Title - Sujet Existing Utility Rehabilitation	
Solicitation No. - N° de l'invitation EZ899-181109/A	Amendment No. - N° modif. 001
Client Reference No. - N° de référence du client	Date 2017-10-19
GETS Reference No. - N° de référence de SEAG PW-\$PWY-031-8186	
File No. - N° de dossier PWY-7-40206 (031)	CCC No./N° CCC - FMS No./N° VME
Solicitation Closes - L'invitation prend fin at - à 02:00 PM on - le 2017-10-31	Time Zone Fuseau horaire Pacific Daylight Saving Time PDT
F.O.B. - F.A.B. Plant-Usine: <input type="checkbox"/> Destination: <input checked="" type="checkbox"/> Other-Autre: <input type="checkbox"/>	
Address Enquiries to: - Adresser toutes questions à: Leung, Janie	Buyer Id - Id de l'acheteur pwy031
Telephone No. - N° de téléphone (778) 919-3273 ()	FAX No. - N° de FAX (604) 775-6633
Destination - of Goods, Services, and Construction: Destination - des biens, services et construction: Parks Canada - Fort Langley National Historic Site - Fort Langley, BC

This Amendment #001 is raised to extend the solicitation closing date, to address questions, and to issue Addendum #1.

**Existing Utility Rehabilitation
Fort Langley National Historic Site, Fort Langley, BC
Solicitation No: E

2. Reference Issued for Tender Drawings, Sheet 6 of 11

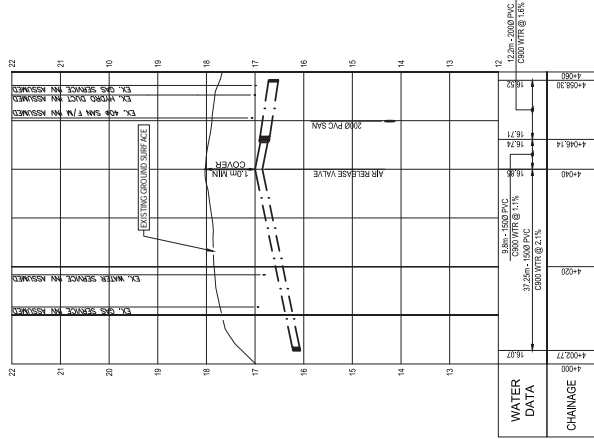
Replace Sheet 6, “Issued for Tender” dated 2017/08/15 with attached Sheet 6 “Issued for Addendum #1” dated 2017/10/18.

- 3. There are bold water lines indicated on sheet 6 without sufficient details for pricing. Please provide additional detail?**

Sheet 6 has been revised and attached to address the missing detail. A note has also been added to indicate the required temporary relocation of the gold panning exhibit. The Contractor will be responsible to reinstate the gold panning exhibit.
